# Cycle Route Audits – Key Findings

## Corridor 1A: Kettering Town Centre to A43 Roundabout.

### North Route (Slide 1 of 5)

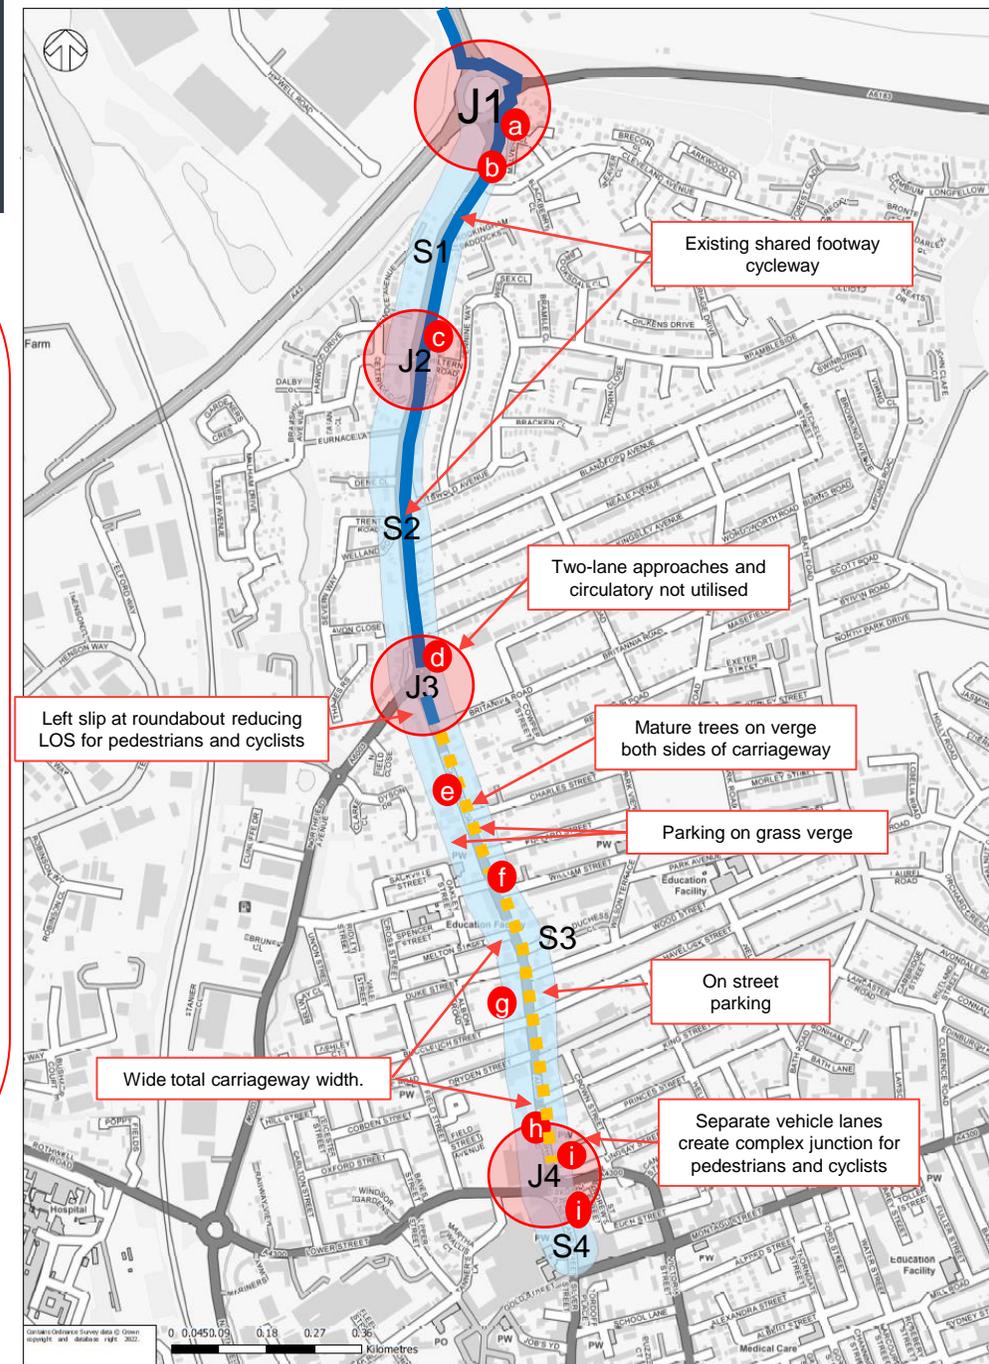
**J1** - is a very busy dual carriageway roundabout junction (A43 / A6183 / Rockingham Road) with three lanes on approach arms. There is existing shared footway cycle provision serving the junction and connecting to the shared use provision on the A43 to the north of the junction. Existing toucan crossings and pedestrian and cycle signage.

**S1** - There is existing shared footway and cycle way provision on the east side of Rockingham Road, but there is a lack of clarity and markings suggesting cyclists re-join the carriageway. Wide verges on both sides of the carriageway, but occasional mature trees on the east side of carriageway. Layby bus stops on both sides of the carriageway.

**J2** - Two lane approach roundabout with uncontrolled pedestrian crossing facilities. Uncontrolled shared crossing on the Chiltern Road arm.

**S2** - Existing shared footway and cycle way provision on the east side of Rockingham Road. Tree lined and layby bus stops on both sides of the carriageway.

**J3** - Roundabout with two lane approaches on Rockingham Road, and one lane approaches on Northfield Avenue and bowling centre. Uncontrolled shared crossing on three arms. Large splitter island from Rockingham Road northbound to Northfield Avenue.

**S3** - Unclear signage of a cycle lane in carriageway, but with faded or non-existent road markings. Lots of parking on tree lined verges both side of the carriageway (photo 'e'). Reasonably wide carriageway width of approximately 7m. Widening to approximately 11m width with central hatching, right-turn lanes and on-street parking to the south of S3, (see photo 'g'). Intermittent and confusing cycle lane markings / sections of shared use for the toucan crossing near William Street (see photo 'f').

**J4** - Signalised junction with separated signals for left turning vehicles. Advance stop lines for cyclist and contraflow access for cyclist onto Newland Street. Complex pedestrian movements with pedestrians having to cross in 3 phases. (Photo i)

**S4** - One-way (northbound) bus and taxi only carriageway with existing contraflow for cycles. Bus and taxi only restrictions in place, but many private vehicles observed. Existing infrastructure for this section to provide a bus depot with four staggered bus laybys, raised kerbs and a taxi bay. No buses used the section while observing. (Photo j)

North Route (Slide 1 of 3)

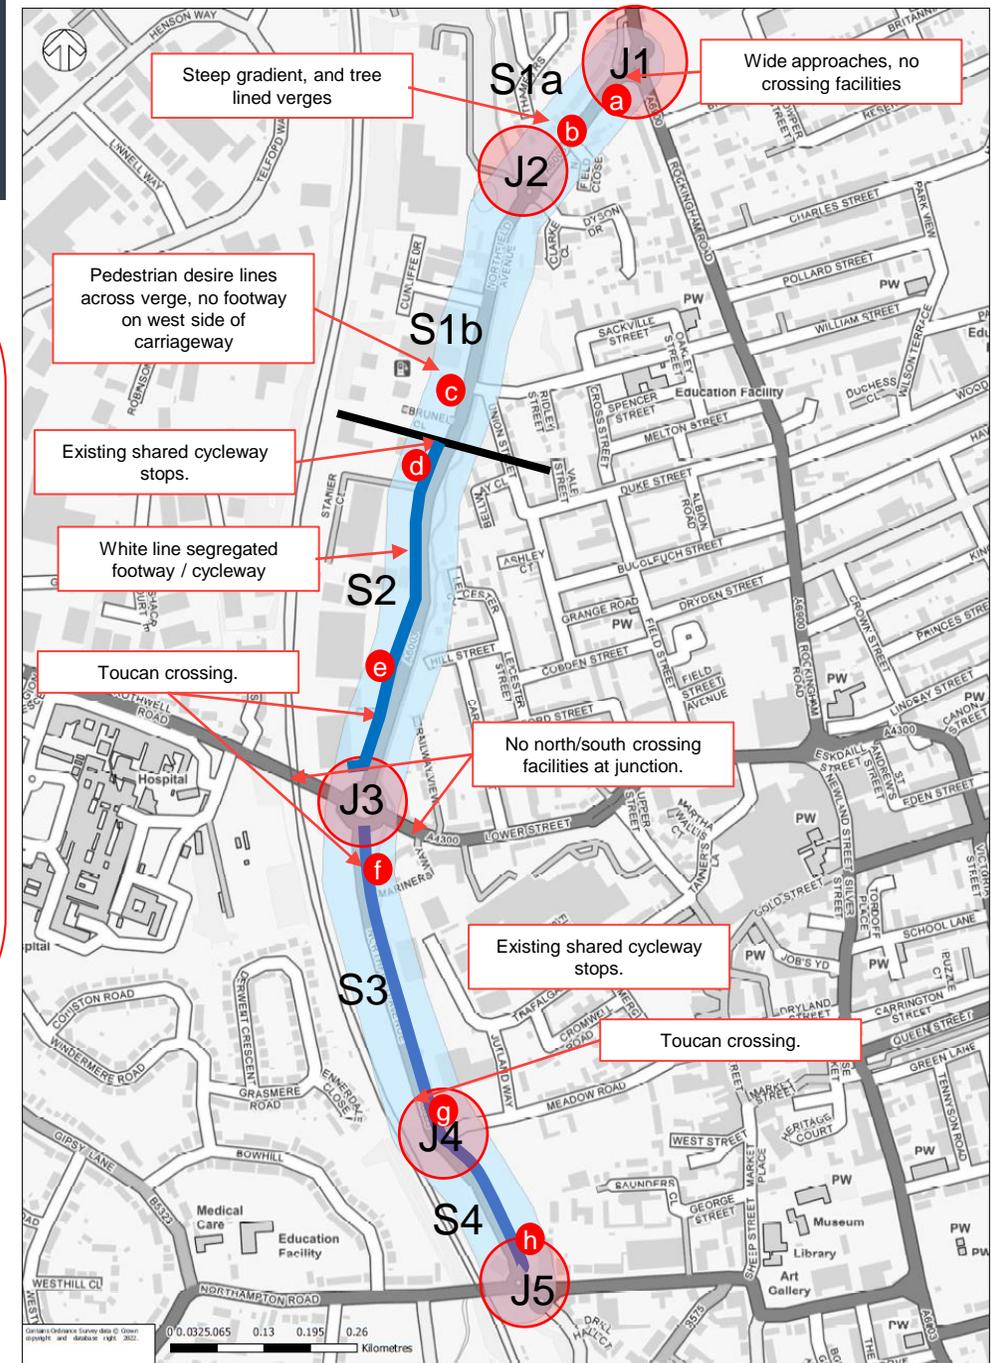
**J1** – Wide approaches on Northfield Avenue and left turn lane from Rockingham Road northbound create difficult pedestrian and cycle movements across the south of the junction. (photo A).

**S1a** – Steep gradient from J2 up to J1. Tree lined verges restrict available space. (photo B).

**S1b** – No pedestrian provision on west side of carriageway. Clear desire lines over the grass verge. (photo C).

**J2** – HGV movements and high vehicle speeds at junction. Missing tactile paving at crossing points.

**S2** – Existing shared footway / cycleway with white line segregation the south of the section. (photo E).

Shared footway/cycleway abruptly ends with clear desire lines over the grass verge. (photo D).

**J3** – Very large, vehicle dominated junction. Toucan crossings for east/west movements, but no crossing facilities for north/south pedestrian or cycling movements near the junction. Railings with excessive overrun areas encroach on footways and create elongate pedestrian routes and creating a vehicle dominated environment.

**S3** – Existing shared use footway on the east side of carriageway, could benefit from some maintenance, dropped kerbs sub-standard for shared use.

**J4** – Three arm mini roundabout, minimal pedestrian/cycle crossing provision, located away from desire lines.

**S4** – Existing shared use footway on east side of carriageway.

**J5** – Intimidating double roundabout with limited pedestrian / cycle facilities. Challenging to cross as a pedestrian or cyclist.

### Northwest Route (Slide 1 of 5)

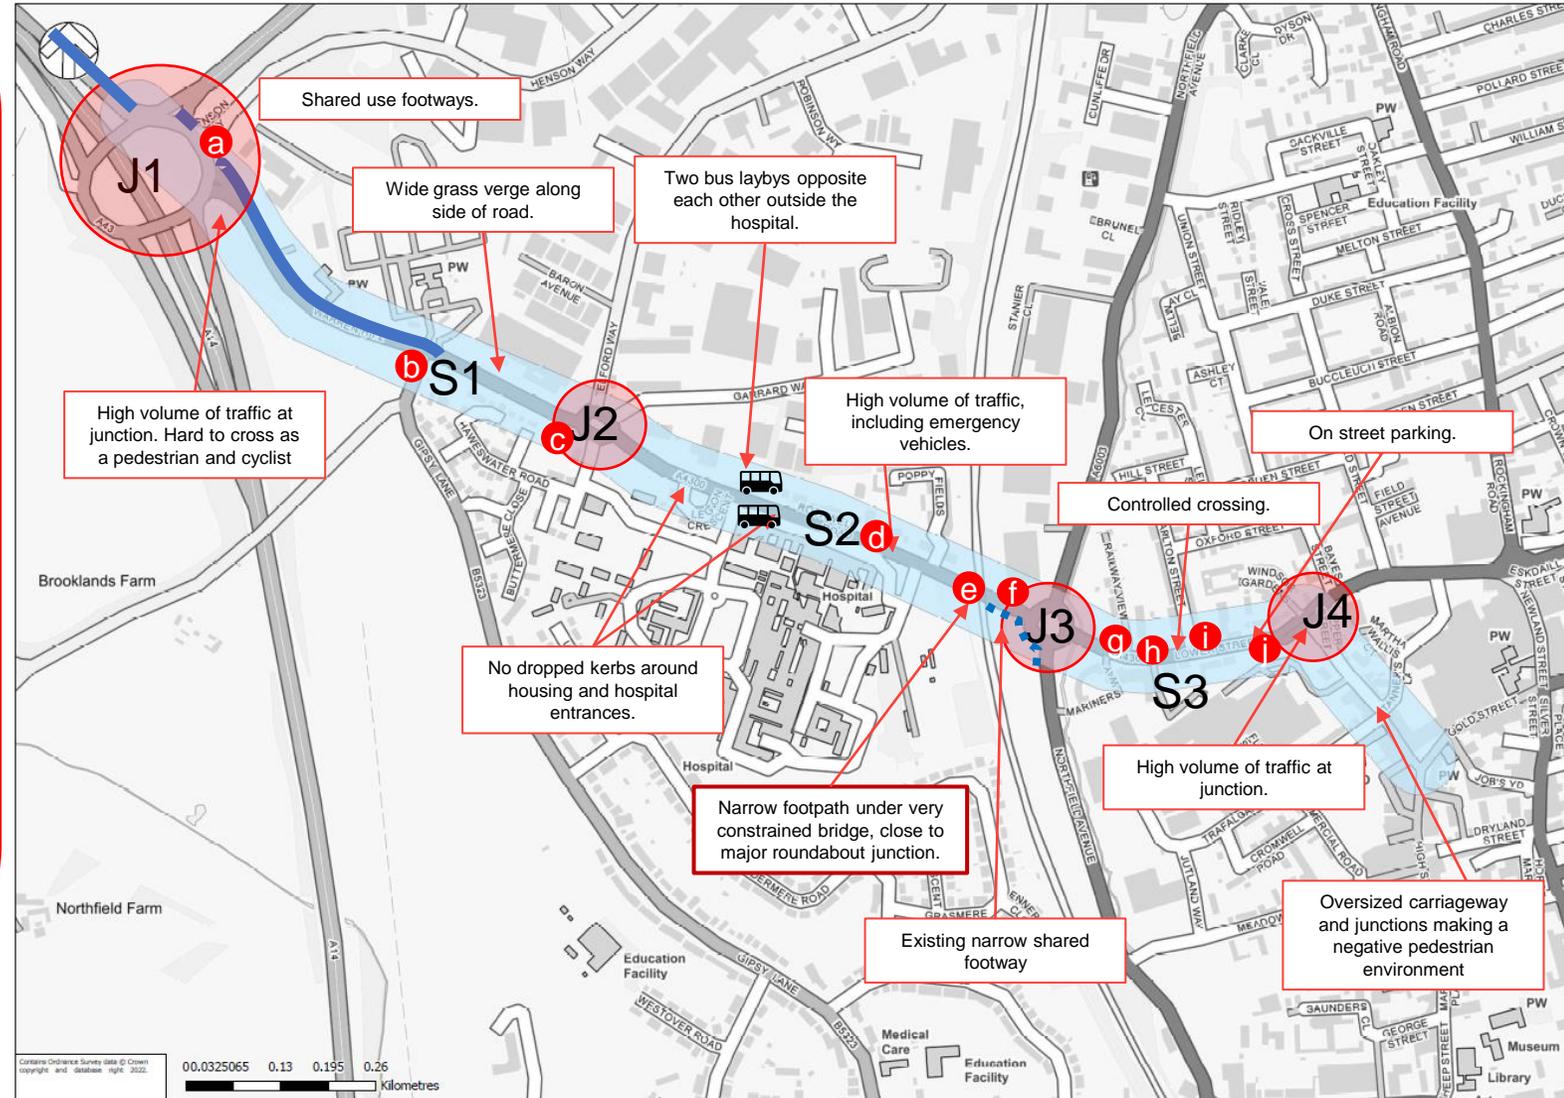
**J1** - high traffic volumes with up to four lane approaches. The junction is partially signalised on some of the approach arms. This aids pedestrian and cycle crossing but there is no dedicated phase and the number of lanes makes it hard for pedestrians and cyclists to safely cross. Overgrown vegetation and poorly maintained footways (photo A), footways feel unsafe and very narrow to walk around.

**S1** – Grass verges and existing shared use footway on the north side of carriageway, although it appears to be below 3m width in places.

**J1** – 5 arm roundabout with 2 lane approaches on most arms. High traffic flows, HGV access to the industrial estate and emergency vehicle movements.

**S2** – Increasing gradient down to J3. High volume of traffic by the hospital. This includes emergency vehicles, causing cars to pull up onto the kerb to let them pass.

**S2** – has on-kerb parking, likely from residents of the houses opposite the hospital.

**S2 / J3** – where they meet the footpath passes under a bridge causing the path to become very narrow

**S3** – on street parking encroaching onto footway (photo G). Steep gradient up to J4.

**J4** – Signalised junction with excessive traffic lanes and left turn lanes, leading to complex junction to navigate for pedestrians and cyclists

### Northeast Route (Slide 1 of 5)

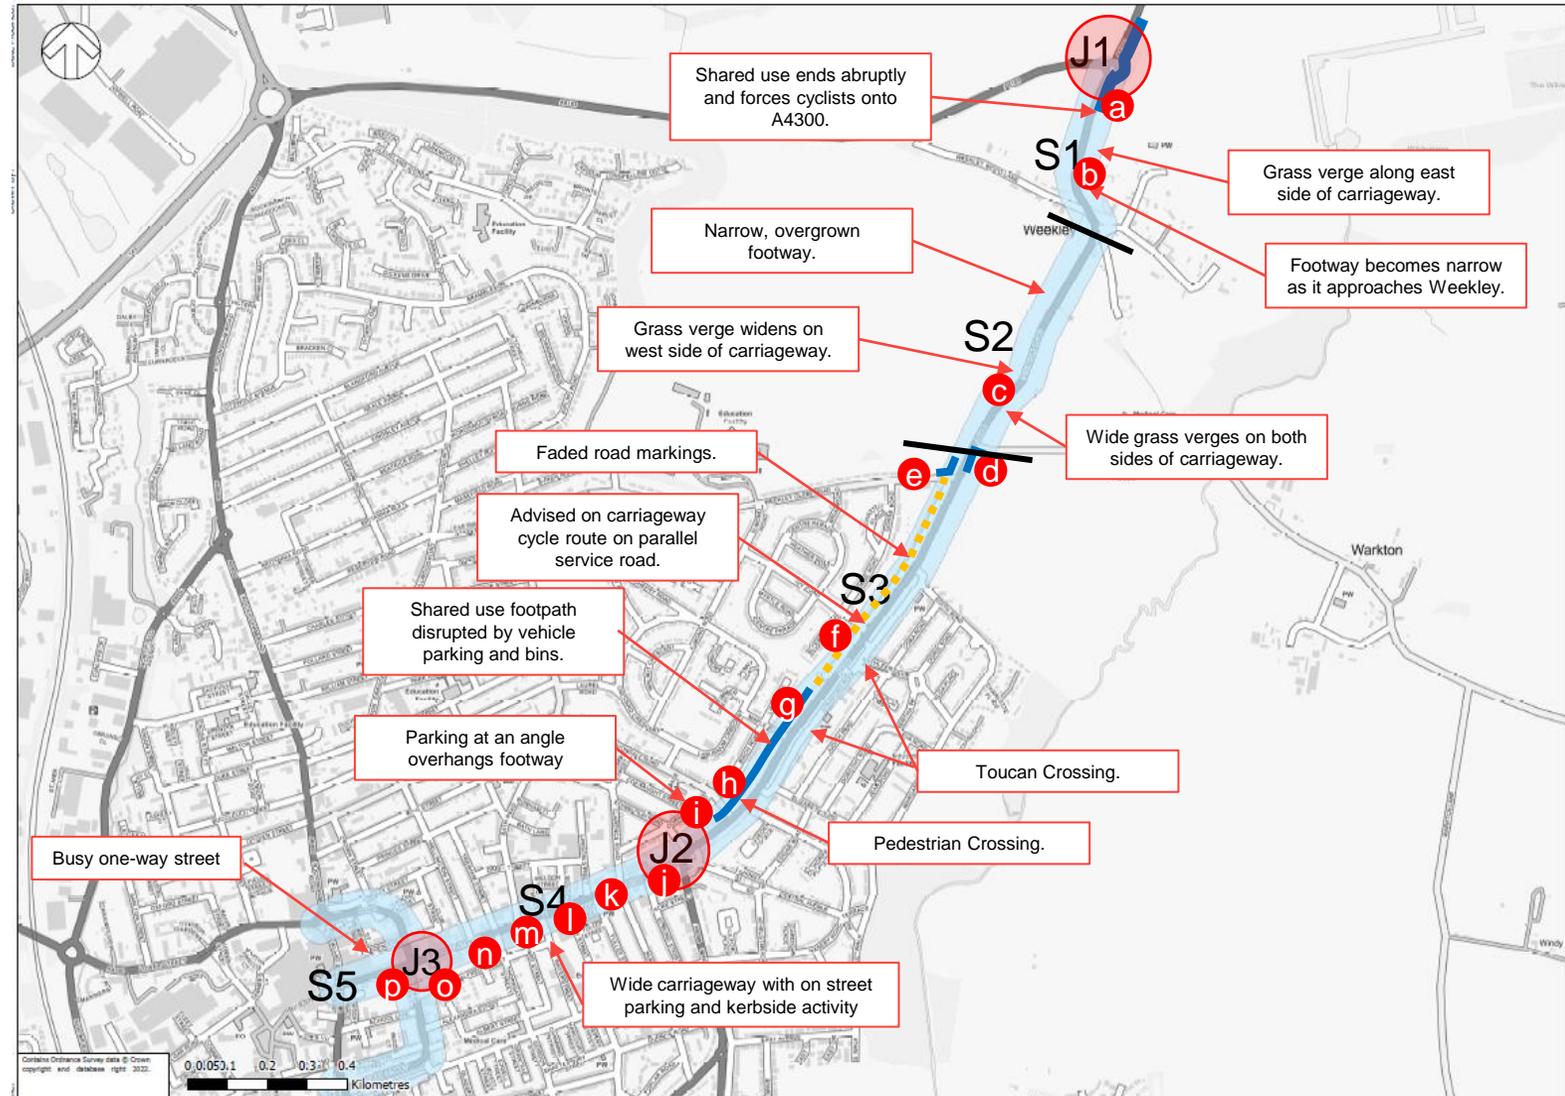
**J1** - Existing shared use footway along the A4300 Stamford Rd to Geddington.

**S1** - Shared use footway ends south of J1 (photo A). Existing footway and verge east of carriageway, but this narrows on the approach to Weekley Village (photo B). HGV movements and traffic speed (30mph limit but perceived higher) make crossing Stamford Rd difficult within the village.

**S2** - Wide verge on west of the carriageway through rural section (photo C).

**S3** - Incoherent segments for shared use footways (photo D). Wide carriageway with verges including some mature trees on both sides. Parallel residential service road, offering quite route currently signposted as an advisory cycle route (photos E and F). Existing shared use footway on the north west of the carriageway, but often blocked by parking and bins on the footway (photo G). Shared use footway ends abruptly without further provision. (photo H). On street parking at a perpendicular angle overhang and blocks footway.

**J2** - Busy 4-arm (3 main arms) roundabout with wide diameter but a painted island. Lack of crossing facilities and dropped/tactile paving. Faded marking in need of improvement. (photo J).

**S4** - Wide section of carriageway with on street parking and kerbside activity (photos K, L). Sections of wide carriageway (12m) with on street parking bays on both side of the carriageway (photo M). Sided by residential and retail properties (photo N).

**J3** - 4 arm signalised junction with ghost island right turn movements. One-way approach from Montague St west and exit on Victoria St south.

**S5** - Eskdail St, Montagu St and Victoria St / School Lane were audited. Montague St was preferred as the more direct and logical route to the town centre and main trip attractors. A busy one-way (eastbound) street with retail and takeaway frontages. On street parking on the north side of the carriageway.

### South Route (Slide 1 of 5)

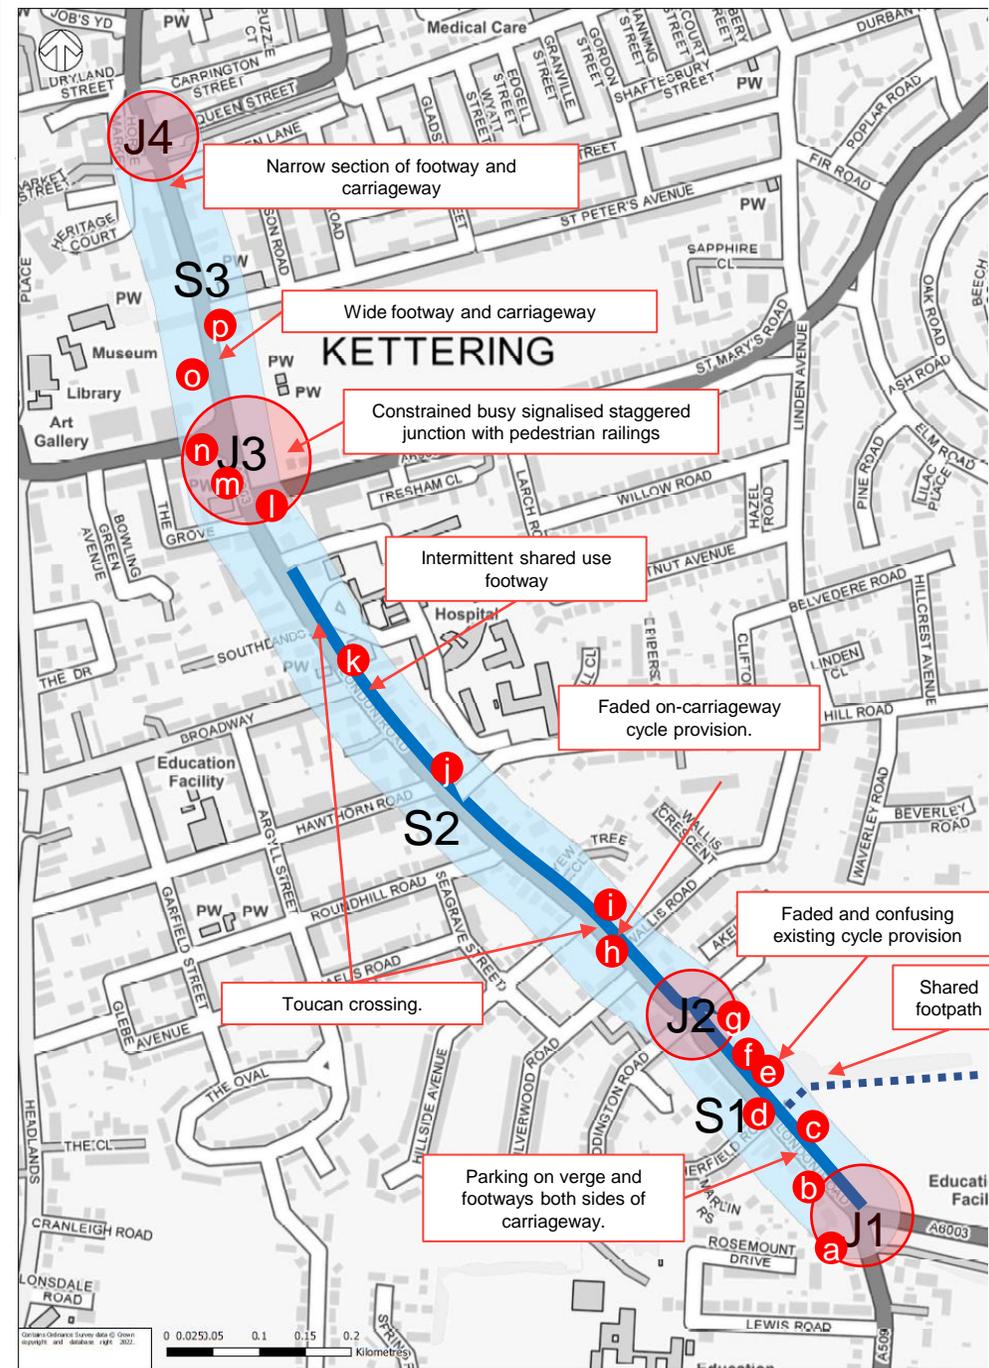
- J1** – Busy compact roundabout with 2-lane approaches on London Rd and Pytchley Rd. A Toucan crossing set back from the junction on Pytchley Rd, but no other pedestrian or cycling provision at the junction (photo A).

- S1** – Busy arterial route with some existing intermittent cycle provision, but faded and confusing. Vehicles parked on verge and footway. (Photo B - F)

- J2** – Wide diameter 4 arm roundabout. Shared use footway cycleway across the northeast of the junction, but unclear, confusing road markings. Cyclists were observed using the carriageway (Photo G).

- S2** – Existing shared use footway on the northeast side of the carriageway, but experiences vehicles parking on verge and footway. Stops short of the junction with St Mary's Road. (Photos H – K).

- J3** – Busy staggered signalised crossroad junction with queuing traffic across the junction. Pedestrian railings on some arms and Advance Stop Lines (ASLs) for cycles on carriageway. Constrained, narrow footway on the west of London Road. More available space, but restricted by pedestrian railings on the east side of the carriageway.

- S3** – Wide carriageway and footways, narrowing to the north of the section. More available space on the east side of the carriageway (Photo P).
- J4** – Busy town centre signalised junction formed of London Rd, Market St, and Horse Market. No pedestrian or cycling crossing facilities on the London Road arm. Unclear and convoluted two phase signalised pedestrian crossing on A6900 Horse Market.
